Change

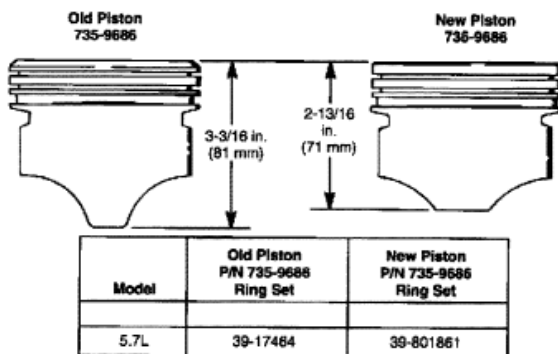
The latest replacement standard pistons (P/N 735-9686) for these engines use a different set of piston rings. The latest piston's oil ring groove is not as deep as the older piston.

If piston rings only are required, refer to the drawings before ordering replacement piston ring sets from the chart.

The latest replacement piston will be shipped with a set of piston rings.
